**Stage 2 Road Safety Audit,  
Dublin Street North, Regeneration  
Scheme, Monaghan Town**

<b>Client:</b>	Monaghan County Council
<b>Document No:</b>	241701-ORS-XX-XX-RP-TR-13g-001_S2_RSA

**Stage 1 Quality Audit Report  
Dublin Street North Regeneration  
Scheme, Monaghan Town**

## Problem No.06: Termination of Proposed Footpaths (DBL-OPE-00-XX-DR-L-901301-Rev 04)

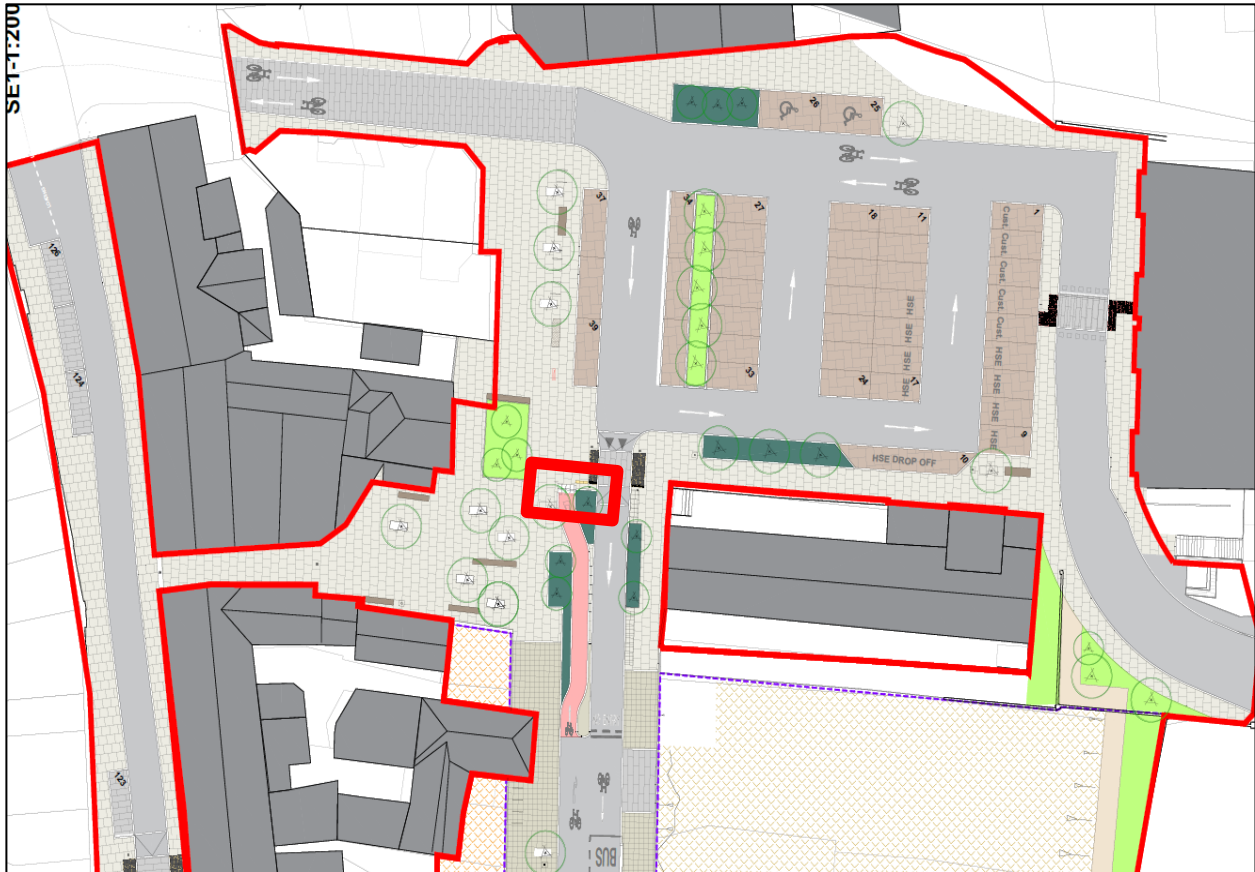
The audit team note from the drawings that the proposed footway works do not appear to connect into any existing pedestrian infrastructure within the area. Lack of an appropriate tie-in to an existing footpath or termination could lead to pedestrian confusion, slips, trips or collisions with vehicles on the carriageway.

The design team should provide provision for appropriate termination of the proposed footpath along with any tactile paving and signage.

## Problem No.08: Swept Path Analysis (DBL-OPE-00-XX-DR-L-901301-04-Rev 04)

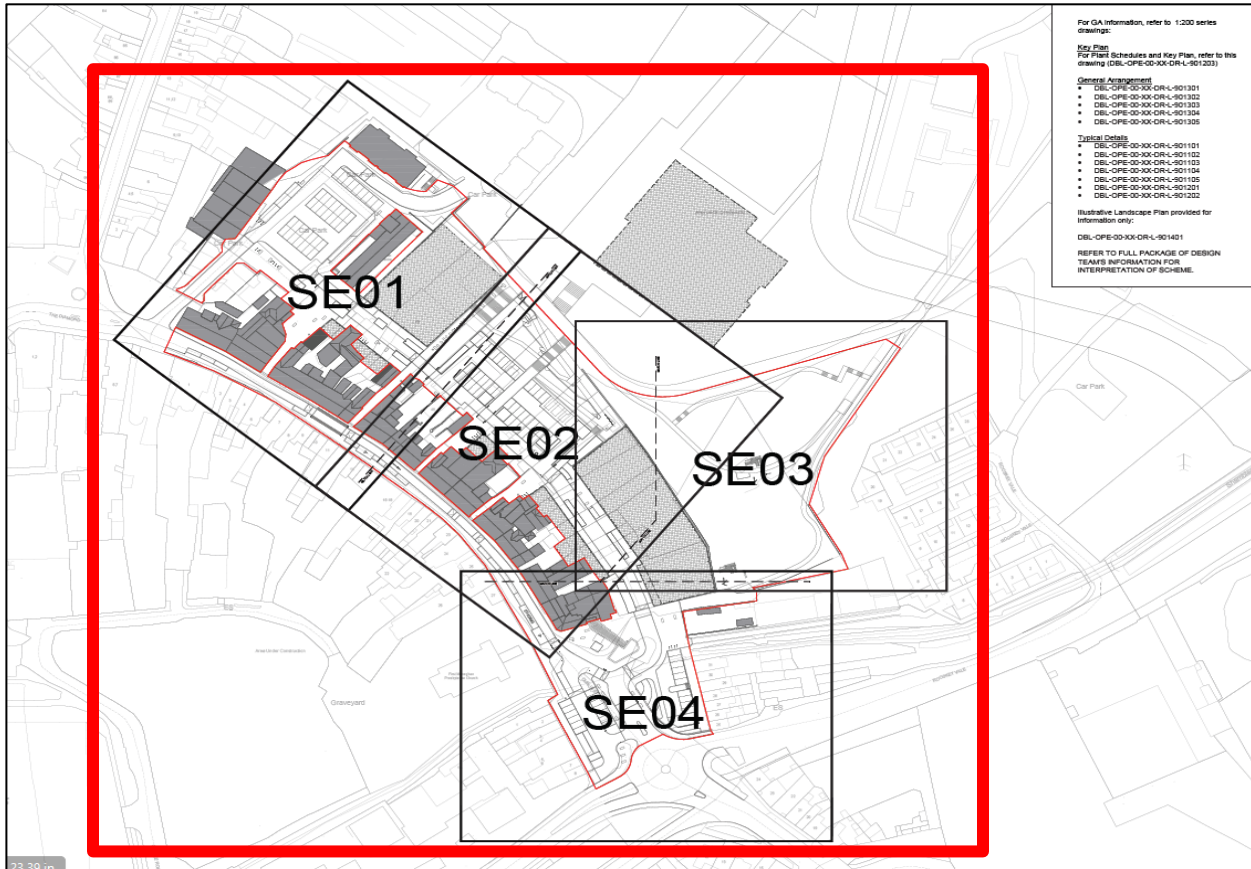
The audit team note from the drawings provided that there is no swept path analysis for service vehicles or buses that must enter the scheme. It is unclear if there is sufficient space to facilitate larger vehicles especially those that must access daily. Lack of swept path analysis for the scheme could lead to instances where vehicles mount footpaths and cycle tracks which could lead to collisions with pedestrians and cyclists.

The design team should provide swept path analysis for the scheme detailing how service vehicles and buses can safely enter and exit the scheme.

## Problem No.09: Bus Stop (DBL-OPE-00-XX-DR-L-901301-Rev 04)

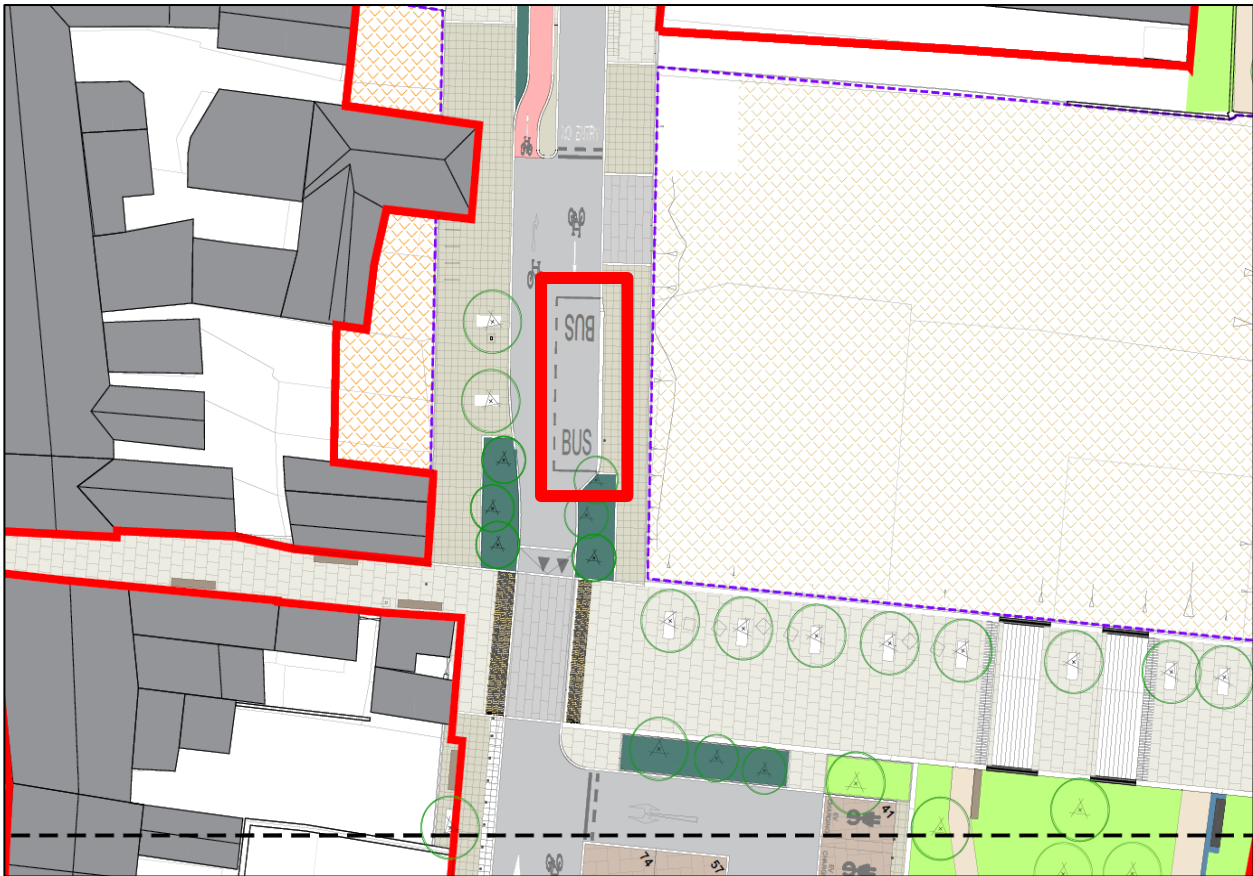
The audit team note from the drawings provided at the location identified. It is unclear from the drawings provided if hazard warning tactile paving, kassel kerbs and the bus stop pole are being provided. The audit team has concerns that visually impaired users may not identify the edge of the bus stop if the appropriate hazard warning tactile paving is not provided, and mobility impaired users may have a higher step up or down from a bus if Kassel kerbs are not provided. This could lead to slips, trips and falls.

The design team should ensure that the bus stop is provided with the appropriate hazard warning tactile paving, Kassel kerbs and the location of the bus stop pole is not in the line of the footpath.

## Problem No.10: Conflicting Road Markings (DBL-OPE-00-XX-DR-L-901301-901302-Rev 04)

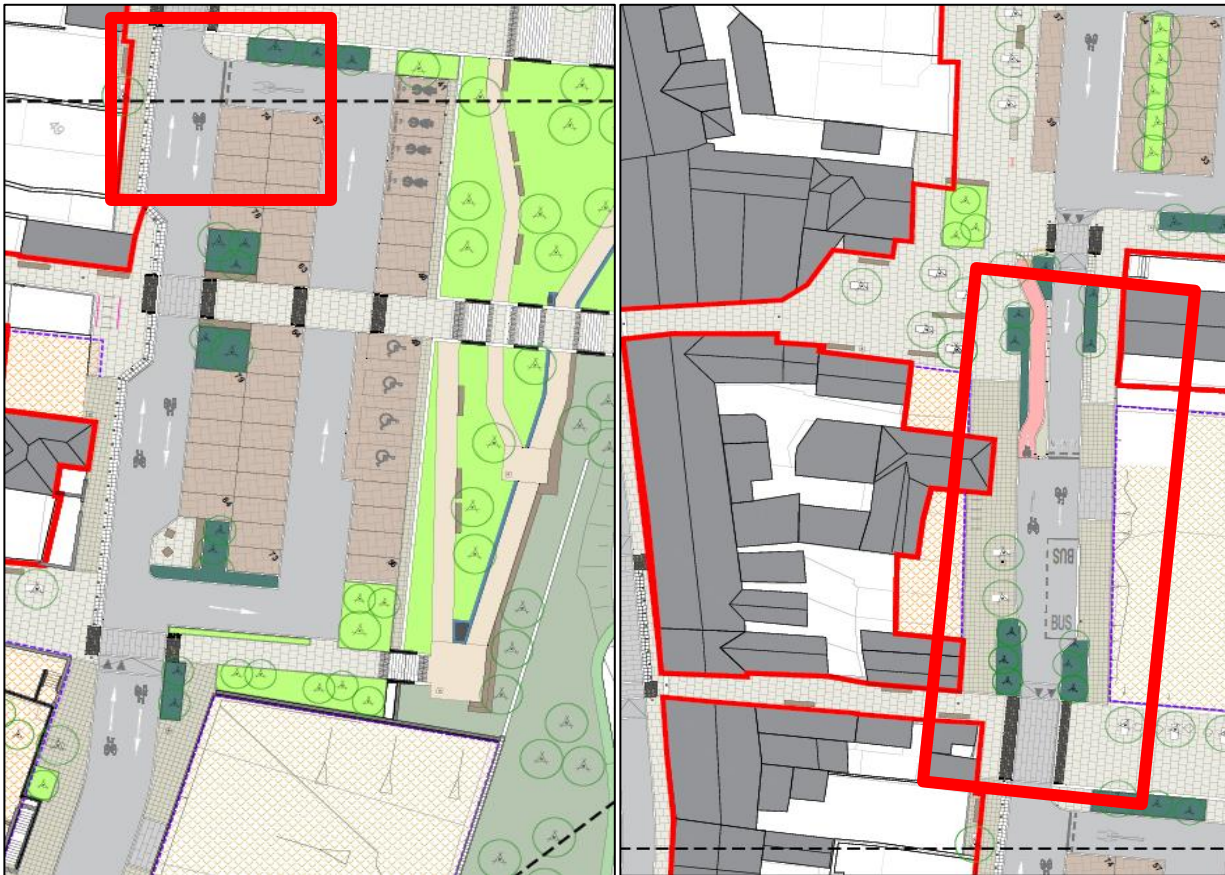
The audit team note from the drawings provided that there appears to be conflicting road markings. Approaching from the north appears to be a one-way system whereas the road markings in the southern car park indicates that two-way travel is possible. The audit team has concerns that these conflicting road markings could lead to motorists misunderstanding the layout and direction of travel around the car park which could lead to driver confusion which could lead to collisions.

The design team should provide clear road markings and signage around the car park and provide any No-Entry Road markings and signage where necessary.

## Problem No.13: Footpath Gradients (DBL-OPE-00-XX-DR-L-901302-901303 Rev 04)

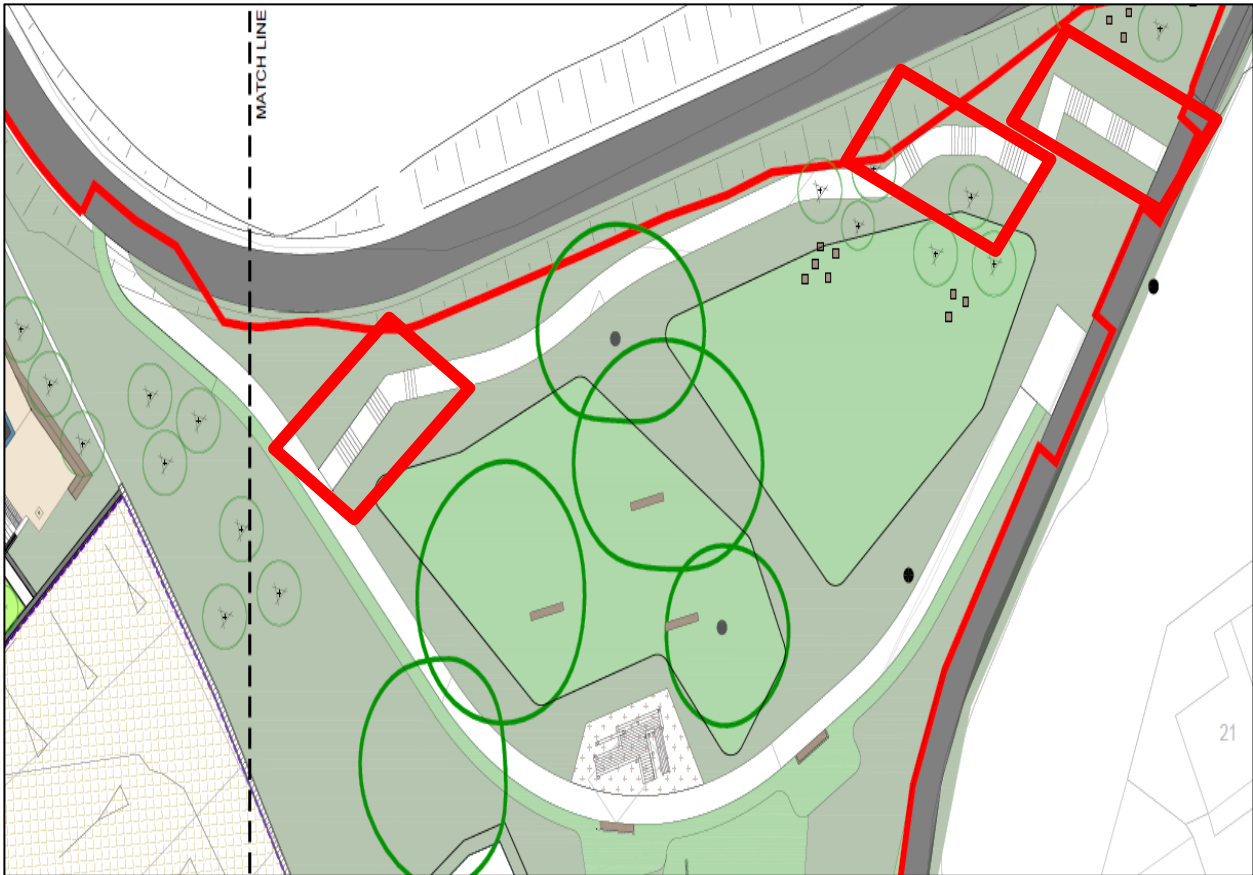
The audit team note from the drawings provided that there are no levels or gradients provided on the proposed footpaths or steps. It is unclear from the drawings provided if the footpaths are considered ramps or gently sloping. The lack of gradients and levels could result in inappropriately positioned intermediate landings, with a lack of rest areas leading to slips, trips or falls.

The design team should provide details of the gradients and levels for the proposed footpath and ensure that no gradient is too steep or an individual ramp flight too long.

## Problem No.15: Inappropriately Located Landscaping (DBL-OPE-00-XX-DR-L-901301-Rev 04)

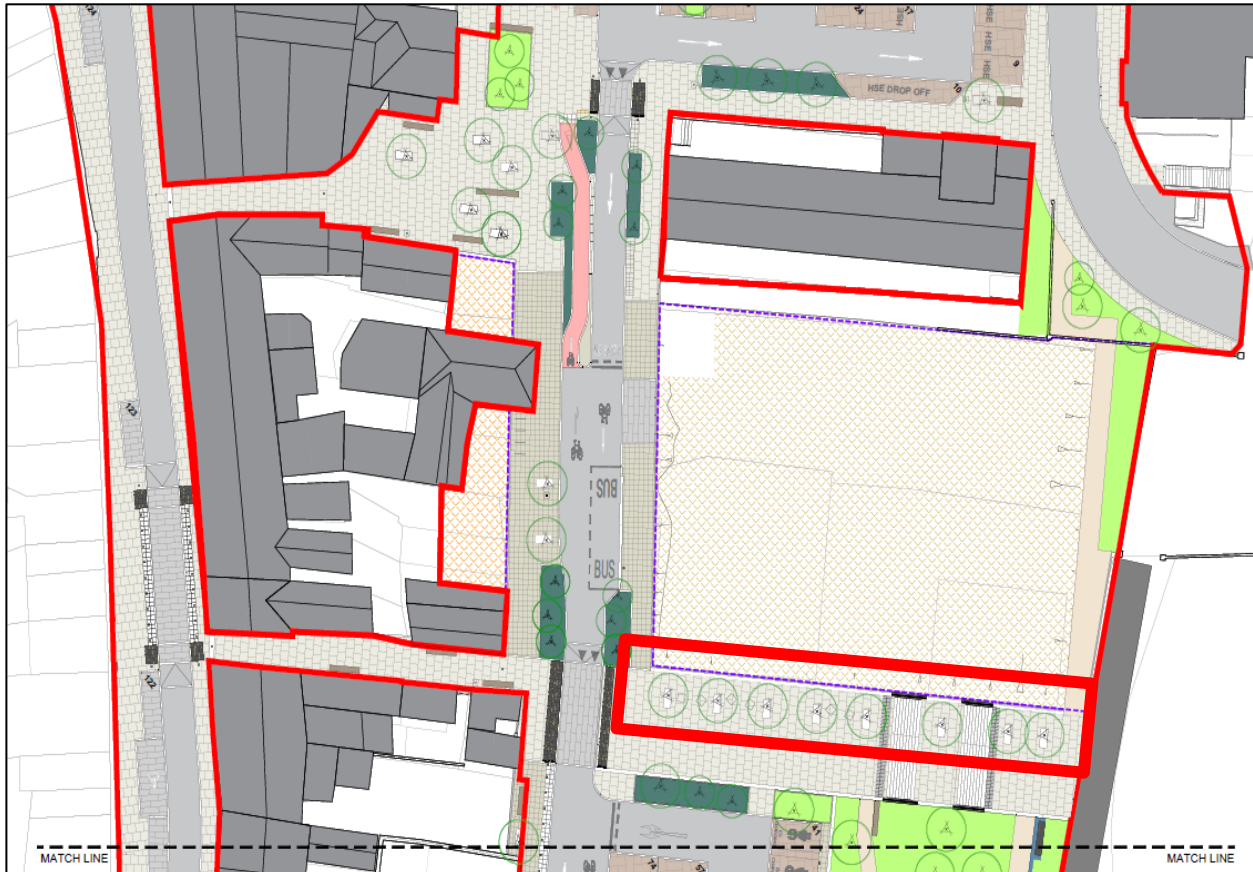
The audit team note from the drawings provided there is landscaping provided in the line of travel of the external stairs. Visually Impaired and Mobility Impaired users especially will have to adjust the path at which they navigate the stairs to manoeuvre around the trees. Additionally, this reduces the space to the handrails on splitting the flights and could lead to slips and trips.

The design team should position landscaping to not impeded the line of travel for the external steps especially where the central handrail extends out past the line of the steps.
